Making EEE GPHY more robust on corner cases

Nov 2008
IEEE 802.3az Task Force

Joseph Chou
Realtek Semiconductor Corp.

IEEE 802.3az November 2008 Plenary Meeting

Case 1 : Slave enters Active state prematurely

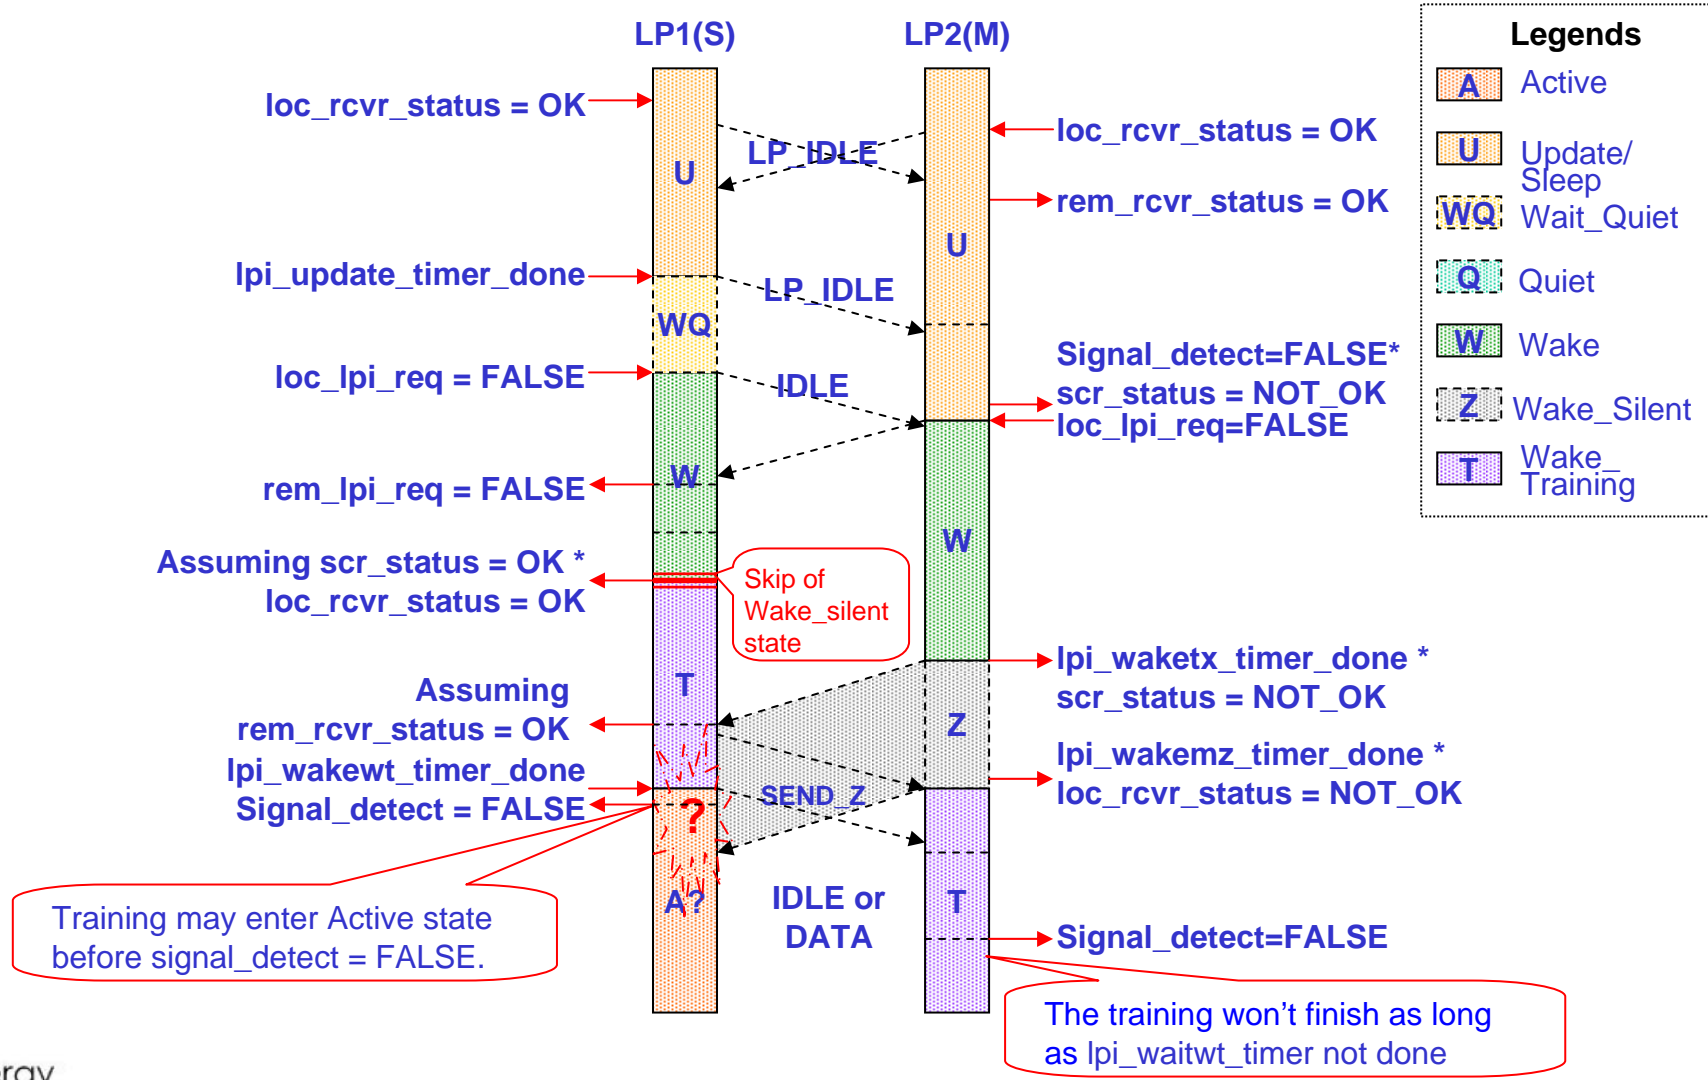
Case 2 : Slave training encounters unstable WAKE signal (from Xiaotong Lin)

Suggested modifications of Fig 40-15b

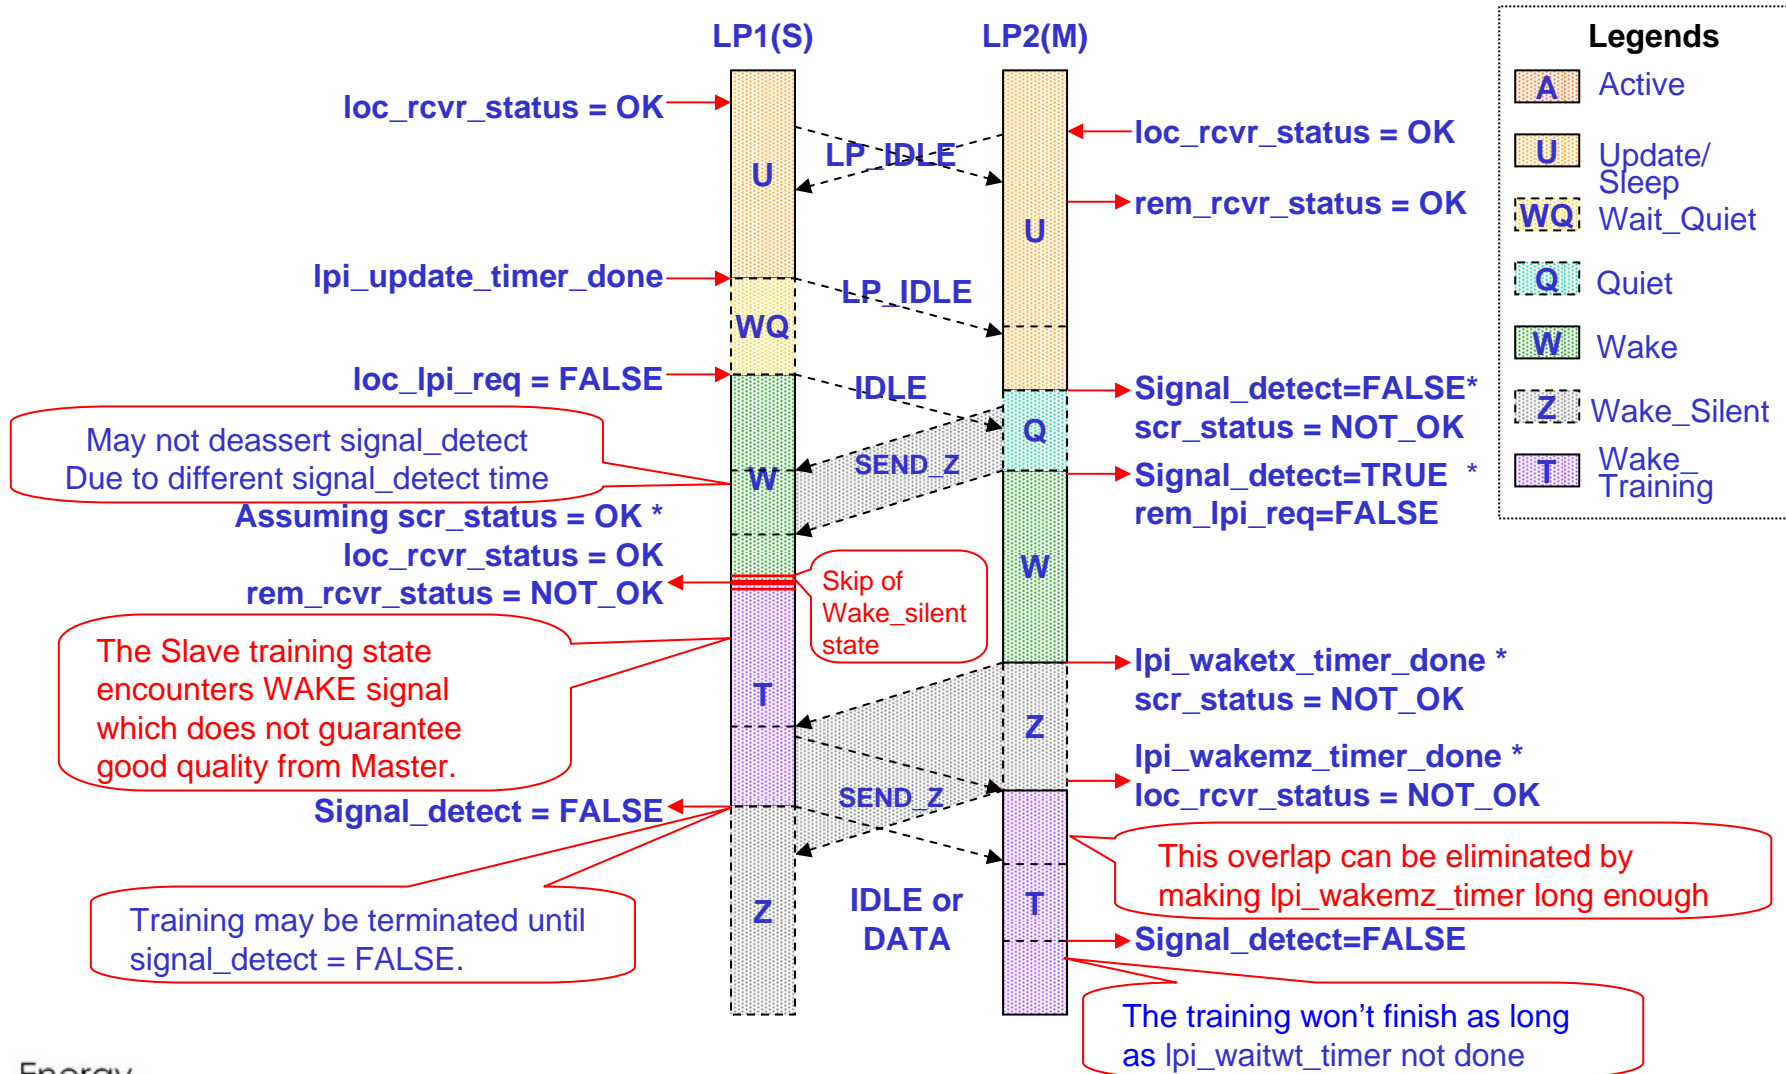
- ❑ During the acceleration of state transition, **the skip of WAKE_SILENT state** (which is similar to Slave_Silent state in non-EEE standard) and improper setting of timer value may cause the Slave device to move to Active state prematurely.

- ❑ Furthermore, in another case, the Slave device may enter Training state while it is still receiving Master WAKE signal which may not have good quality.
